New Fuel Pump Assembly Kit for DBW 2010 Heaters - Part Number 906073B

08/10/2000

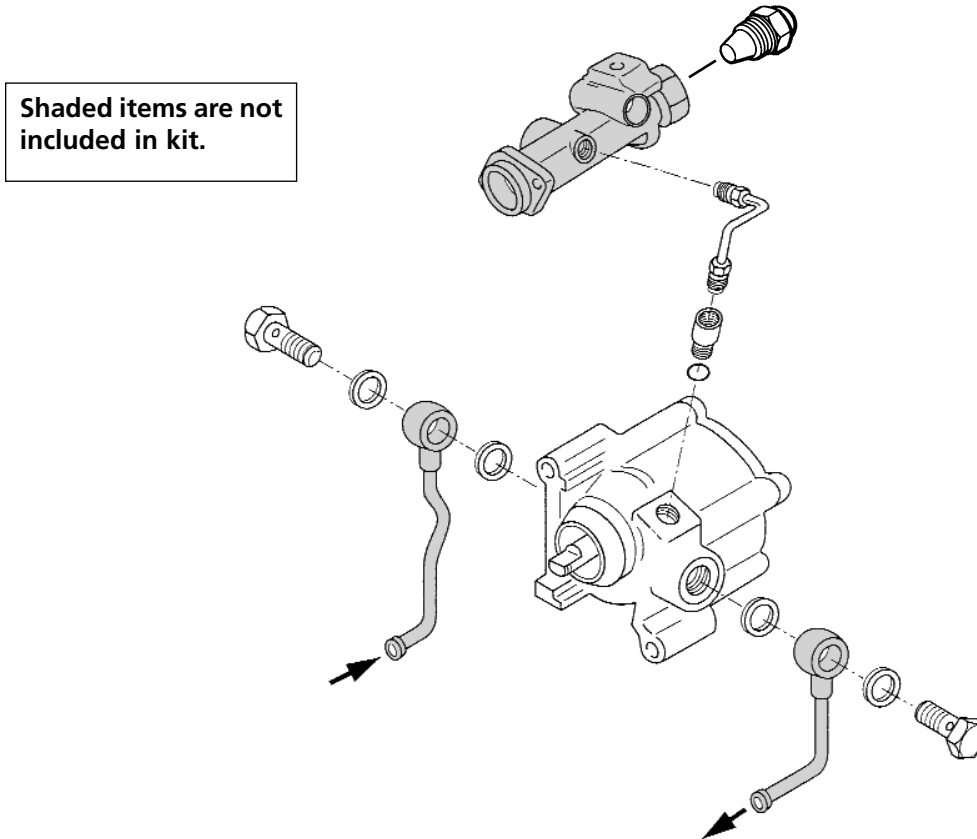
A new 10 bar (145 psi.) fuel pump assembly kit is now available as a replacement for all former 8 Bar (116 psi.) and 7 Bar (100 psi.) fuel pumps 42977B and 65516A as used on the DBW 2010 coolant heater.

The new fuel pump assembly kit is available under part number 906073B and includes all hardware to upgrade existing heaters to the new standard when fuel pump replacement is required. Refer to the assembly instructions included with the assembly kit.

Included with the assembly kit is a 0.35 gph. fuel atomizing nozzle. When upgrading earlier DBW 2010 coolant heaters with the 8 bar (116 psi.) and 7 bar (100 psi.) fuel pump, the 0.40 gph. nozzle must be replaced with the new 0.35 gph. nozzle included in the kit.

DO NOT reuse the earlier 0.40 gph. nozzle with the new 10 bar (145 psi.) pump as over fueling of the heater will occur resulting in combustion chamber and heat exchanger damage.
